# Access Compliance Report

## Public Rights-of-Way

### (Curb Ramps)

Intersection ID: 6715	Main Street: ONEIDA_RD	Cross Street: TEWKESBURY_RD	Location: S
ADA ID: DD51D12B4979	Ramp Type: Perp	Initial Pass/Fail: Fail	Overall Compliance: No
Severity Score: 37.5			
Codes/Mitigation Info/Possible Solution		Field Measurements/Component Compliance

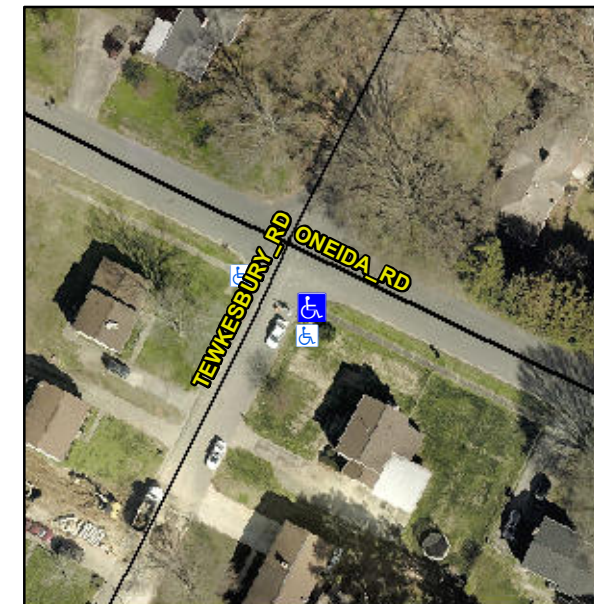
**Not Found, R304.2.2, R304.5.3**

Compliance	Description	Data	Compliance	Description	Data
N/A	Ramp Length (in)	68.0	No	Ramp Slope (%)	9.0
Yes	Ramp Width (in)	48.0	No	Ramp XSlope (%)	9.5
N/A	Flare Type LT	N/A	N/A	Flare Type RT	N/A
N/A	Flare Slope LT (%)	N/A	N/A	Flare Slope RT (%)	N/A
N/A	Flare Traversable LT?	N/A	N/A	Flare Traversable RT?	N/A
N/A	Landing Length (in)	N/A	N/A	DWS Provided?	N/A
N/A	Landing Width (in)	N/A	N/A	DWS Contrast?	N/A
N/A	Landing Slope (%)	N/A	N/A	DWS Length (in)	N/A
N/A	Landing X Slope (%)	N/A	N/A	DWS Full Width?	N/A
N/A	Landing Curb? (Y/N)	N/A	N/A	DWS Offset (in)	N/A
N/A	Shared Landing?	N/A			
N/A	Gutter Ponding?	N/A	N/A	Gutter Slope (%)	N/A
N/A	Gutter Lip Ht (in)	N/A	N/A	Gutter X Slope (%)	N/A
N/A	Painted X Walk1?	No	N/A	Painted X Walk2?	N/A
	X Walk 1 Direction	To NW		X Walk 2 Direction	N/A
N/A	X Walk 1 Width (in)	N/A	N/A	X Walk 2 Width (in)	N/A
	X Walk 1 Slope (%)	1.1		X Walk 2 Slope (%)	N/A
	X Walk 1 X Slope (%)	9.9		X Walk 2 X Slope (%)	N/A

**Remove & Replace Entire Ramp.**
